Stantec Consulting Services Inc.
1060 Andrew Drive, Suite 140
West Chester PA 19380

November 29, 2021
File: 213403364

**Reference: Response to Public Comments
Second Remedial Investigation Report Addendum,
Area of Interest 9
Sitewide PADEP Facility ID No. 780190
AOI 9 eFACTS PF No. 778379
Former Philadelphia Refinery
3144 Passyunk Avenue
City of Philadelphia
Philadelphia County**

Figure 1. Cross Section A-A'

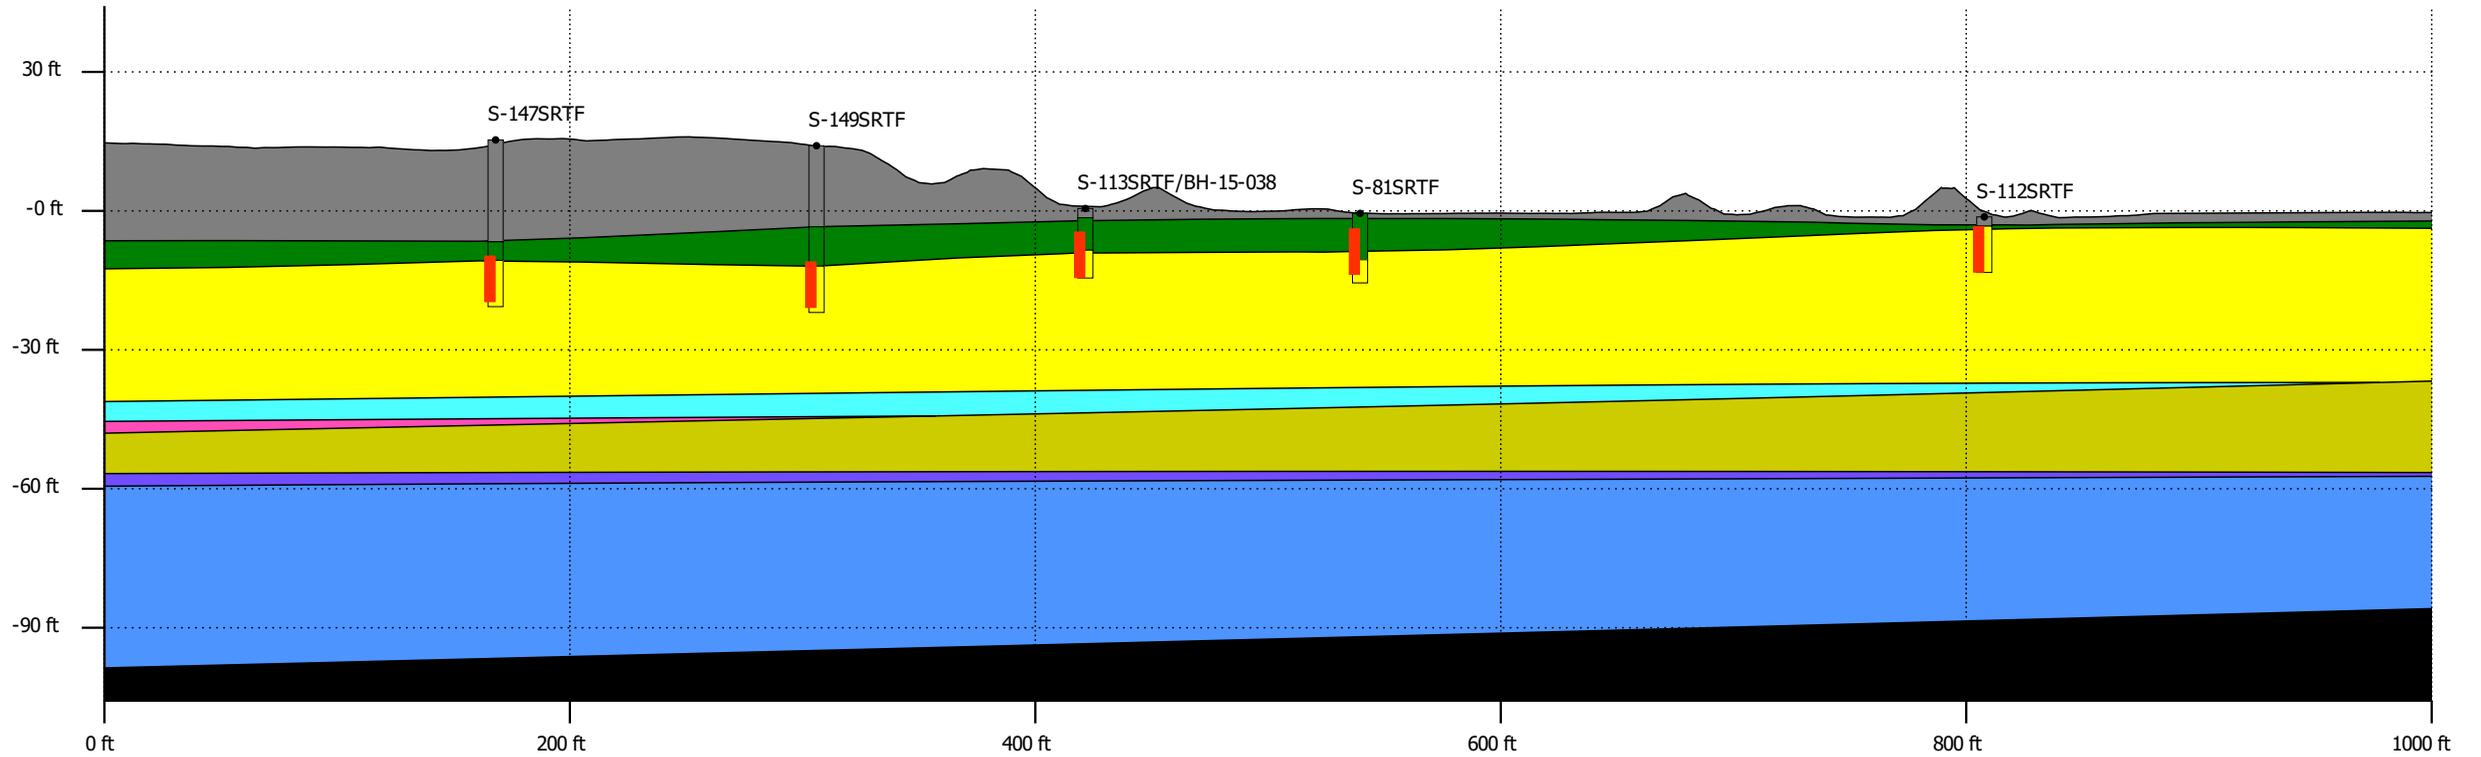
This comment is closely related to Comment 4a and should be reviewed in conjunction with that response regarding the concepts and validity of Evergreen's fate and transport assessment. In addition to Comment 4a's response, Figure 1 has been created and incorporated into this response to address offsite well screen placement. Onsite contaminants such as benzene are present in the water table which under Mingo Basin pumping conditions is contained in mostly granular deposits of the Pleistocene-age alluvium mapped across AOI 9. Pleistocene-age deposits are commonly muddy nearer the ground surface at AOI 9 and of variable thickness, sometimes overlain by marsh muds of Holocene-age. There is also substantial urban fill offsite under Essington Avenue. Offsite wells were constructed to be screened below the surface fill and uppermost muddy deposits so that they would intersect the sandy Pleistocene deposits where the contaminants would be most likely to migrate. Given these conditions and as shown by Figure 1, the well screen elevations are not always the same. The number of wells installed is subjective and based on professional judgement, property access, and the objective of sufficient delineation under Act 2.

See 2021 Addendum Report (AOI-4), Figure 4-2a - Lower Aquifer Elevation June 2019 (pdf page 161 of 307).

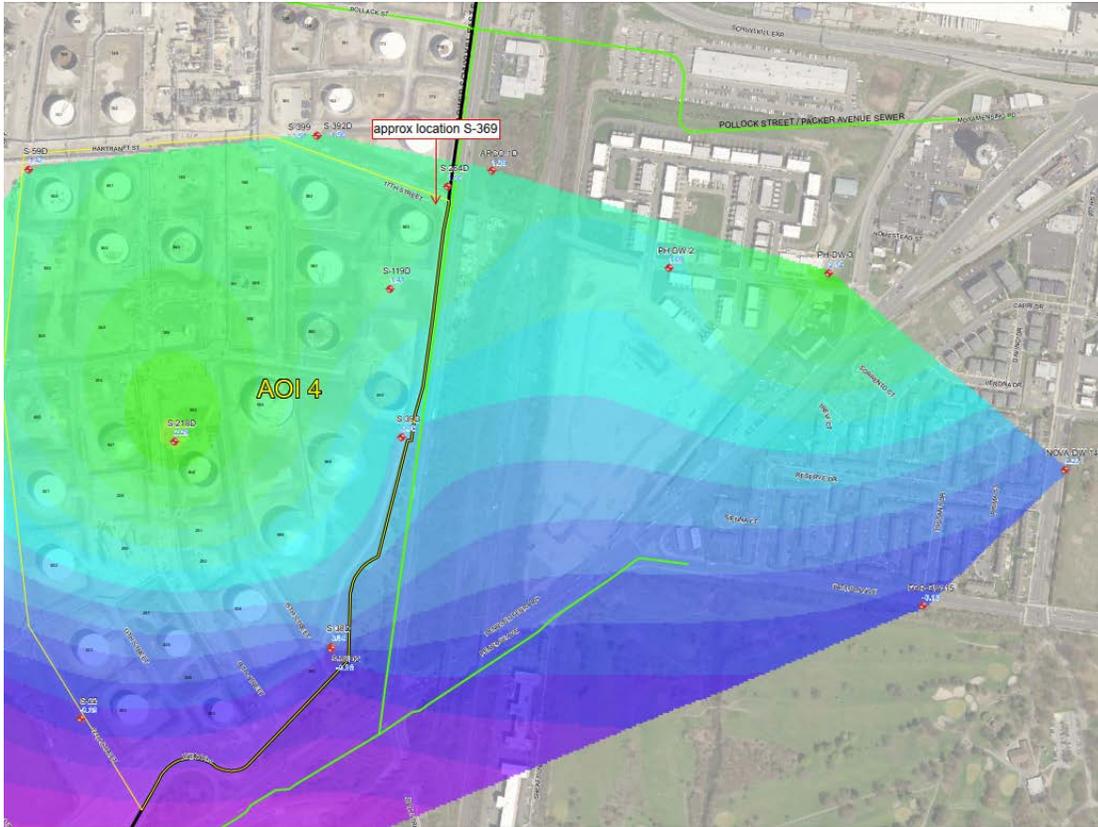
But Evergreen disregarded the Department’s request. It has not installed an off-site unconfined well anywhere near S-369. Instead, it has focused unconfined aquifer evaluations on the southernmost boundary of AOI-4 near the Penrose Avenue remedial system.

Sunoco has access to deep aquifer wells to the east and southeast of S-369 where similarly placed shallow aquifer wells could be positioned. Figure 4-2a of the 2021 Addendum Report illustrates the access and recent gaging of lower aquifer wells positioned off-site and east and southeast of S-369:

See id., Figure 4-1e - Unconfined Aquifer Elevation April 2021, with Penrose Ave Remediation system polygon, line and point features superimposed. Other areas of AOI-4 and adjoining boundaries should be overlain similarly.

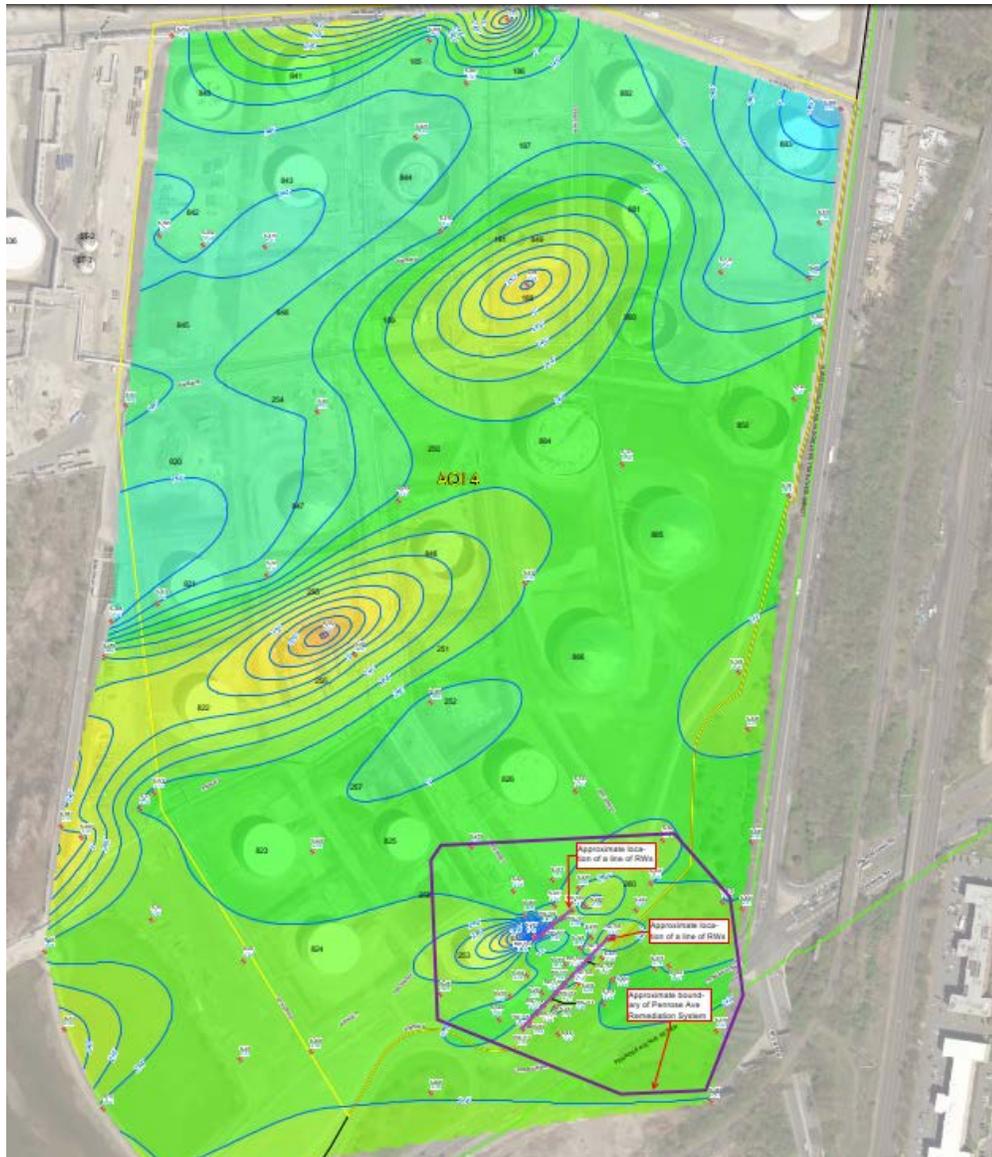
Cross referencing Figure 4-1e with the location of the Penrose remediation system and extraction points, it appears that potential groundwater mounds centering on shallow monitoring

wells (S-104, S-96, S-371) are not explained. Perhaps remedial systems, perching conditions, well construction or other factors can be attributed to the contours surrounding these wells taking a mounding shape. But this should be analyzed.

Such overlays may also help to explain the shapes of other areas contoured on Sunoco Figures 4-1a through 4-1e (perhaps with mounded, drawdown, convergence around sewers, or other unexplained shapes). An example of an overlay for the Penrose remediation system is shown below superimposed on Figure 4-1e:

See *id.*, Figure 1 -- Penrose Avenue Area Proposed Offsite Well Locations (pdf page 58 of 63).

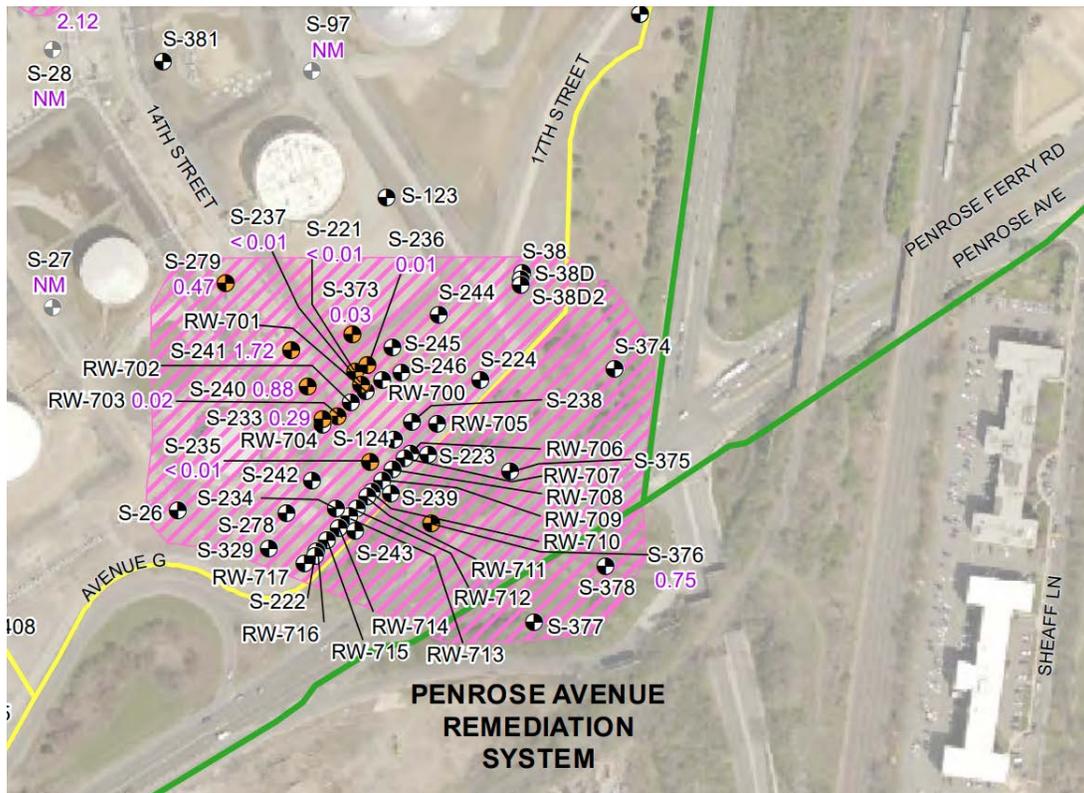
letter dated June 21, 2017 due to lack of offsite wells. In 2018, five additional monitoring wells (S-374, S-375, S-376, S-377, and S-378) were installed offsite adjacent to the Penrose Avenue Remediation System. Evaluation of these wells is conducted during quarterly groundwater gauging events. A geophysics survey was conducted in February 2020 to further investigate the offsite conditions. Soil and water samples as well as additional monitoring wells are currently being installed to confirm output from the geophysical survey. A RIR Addendum will be submitted in the future to summarize available offsite information.

Response to Comment #1: On June 28, 2017, Stantec provided PADEP with a map of the proposed locations of up to five offsite monitoring wells via electronic mail (Figure 1). The proposed well locations were selected based on a telephone discussion between the PADEP, Evergreen, and Stantec on June 26, 2017, during which the extent of offsite delineation of the RIR-modeled groundwater plume was discussed. It was agreed that groundwater data collected from wells installed within the Pennsylvania Department of Transportation (PennDOT) right-of-way would be sufficient to the PADEP for usage in future groundwater fate and transport model calibration for the referenced plume in the unconfined aquifer.

Stantec and Evergreen request that the PADEP provide confirmation that the offsite monitoring well locations proposed on Figure 1 are satisfactory for delineation purposes.

See 2021 Addendum Report (AOI-4), pdf page 166 of 307, Figure 4-4 (Maximum Benzene Concentration Unconfined Aquifer, 2014-202).

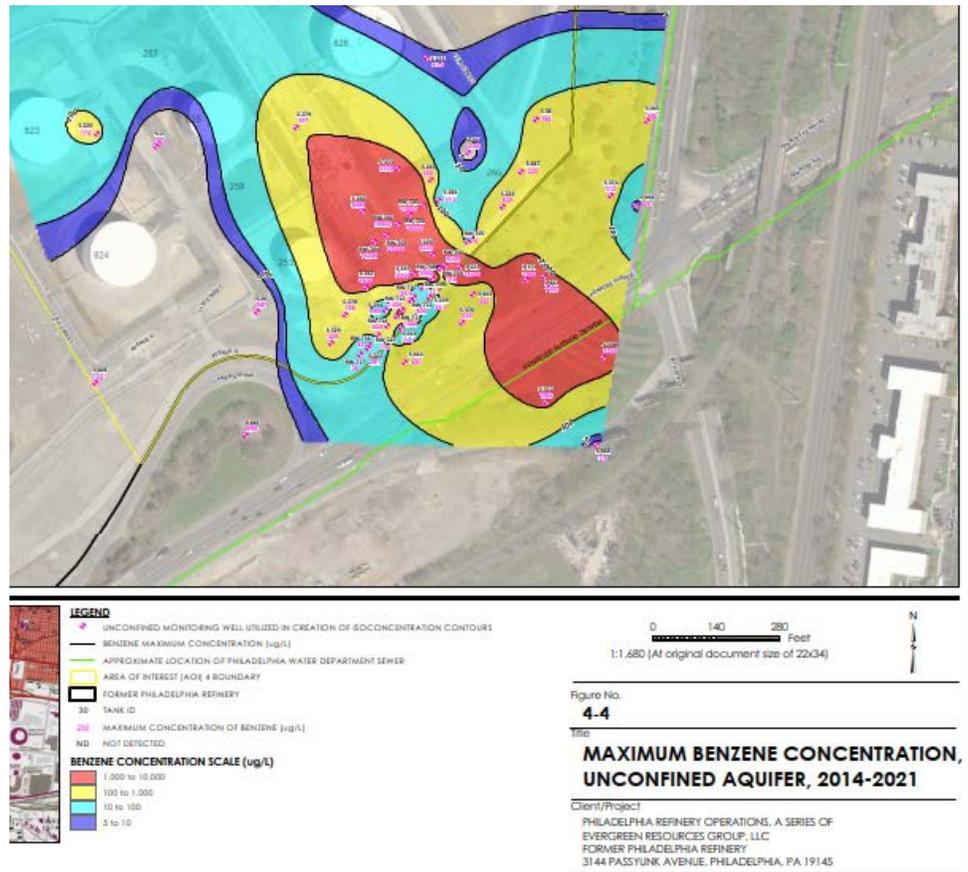
The effects of Penrose Avenue and Lower Schuylkill East Side Intercepting sewers on the migration of contamination would be critical to understanding groundwater flow and support Sunoco's placement of monitoring wells. In fact, the contamination mapping shows benzene to be migrating beyond the sewer as shown below in Figure 4-4:

- Figure 4-4 presents an updated maximum benzene concentration map for the AOI 4 unconfined aquifer for the period 2014-2021 (period overlaps previous RIR datasets but is consistent with the data being used for Evergreen’s Sitewide Fate and Transport RIR). Figure 4-7a displays benzene and other exceedances for samples collected since the AOI 4 RIR. The pattern of benzene impacts above the SHS indicate source(s) spatially related to areas where LNAPL has previously been observed in wells, and where tankage records indicate a long history of refinery product storage. In the area southeast of AOI 4, the estimation of benzene concentration has been extended offsite using the new sample dataset maximums. The well data consistently indicates an offsite area of elevated benzene in groundwater with an offsite core centered across Penrose Avenue including wells S-375, S-377, and S-378. Decreases in benzene maximum concentrations of up to three orders of magnitude to concentrations below the SHS are demonstrated for wells S-440, S-448, S-444, and S-446. Groundwater data from Provo property wells for November 2018 indicate flow towards Penrose Avenue converging around the Penrose Avenue Sewer (see Figure 4-1a), and 2017 Provo well analytical data, available for select wells shown in the figure, indicate non-detects or low-level benzene detections. These conditions support delineation in that direction. Given benzene concentration data alone, wells S-378 and S-445 may not demonstrate sufficient delineation on the east side of the area; however, the forensics data discussed in the next two bullets provides the important lines of information supporting the presence of offsite benzene source(s).

See 2021 Addendum Report (AOI-9), Figure 4-5 Maximum Benzene Concentration Unconfined Aquifer, 2014-2021 (pdf page 127 of 307).

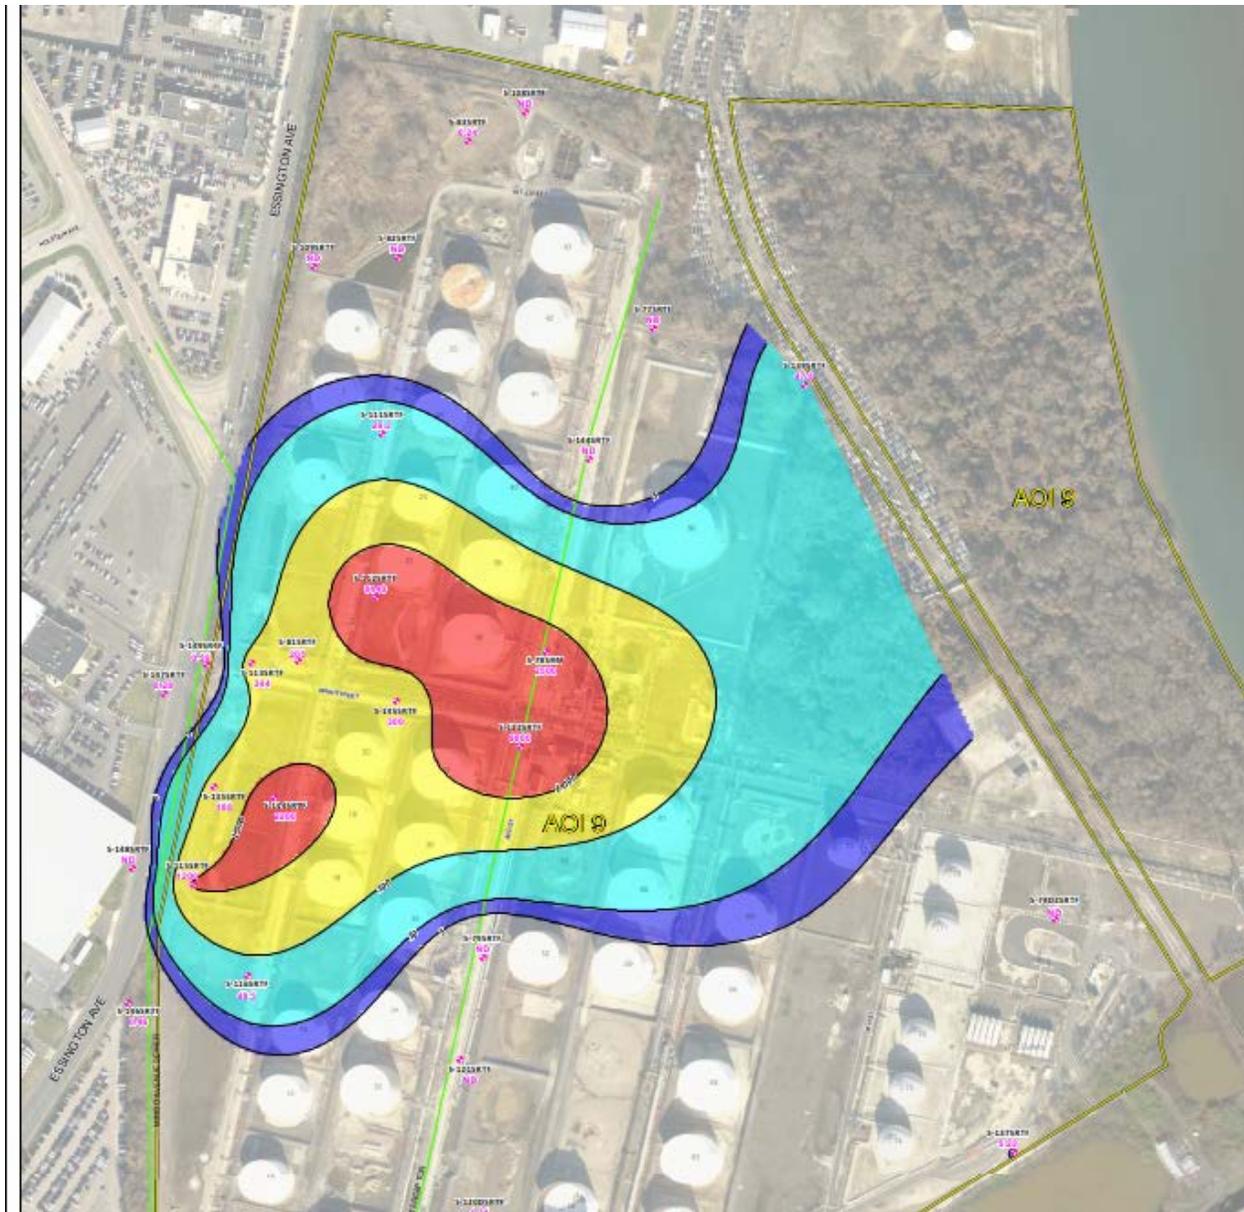
Evergreen's Figure 4-5 maximum benzene concentration unconfined aquifer 2014 - 2021 groups the highest benzene concentrations onto a single map. But mapping isoconcentration in this manner does not illustrate how the contamination plume has changed in time over the period 2014 through 2021:

- Figure 4-5 presents an updated maximum benzene concentration map for the AOI 9 unconfined aquifer for the period 2014-2021 (period overlaps previous RIR datasets but is consistent with the data being used for Evergreen's Sitewide Fate and Transport RIR). The pattern of benzene impacts above the SHS indicate source(s) spatially related to areas where LNAPL has been observed, and where tankage records indicate a long history of refinery product storage. Concentrations decrease a few orders of magnitude to the west up to the offsite delineation wells. The forensics interpretation presented in Appendix H indicates that a petroleum release likely occurred near well S-122SRTF in November 2016 that has led to enrichment of benzene in groundwater. This and other documented recent releases are not attributable to Sunoco legacy; however, they may have impacted the benzene plume conditions (e.g., Figure 4-9a; wells S-122STF and S-78SRTF).
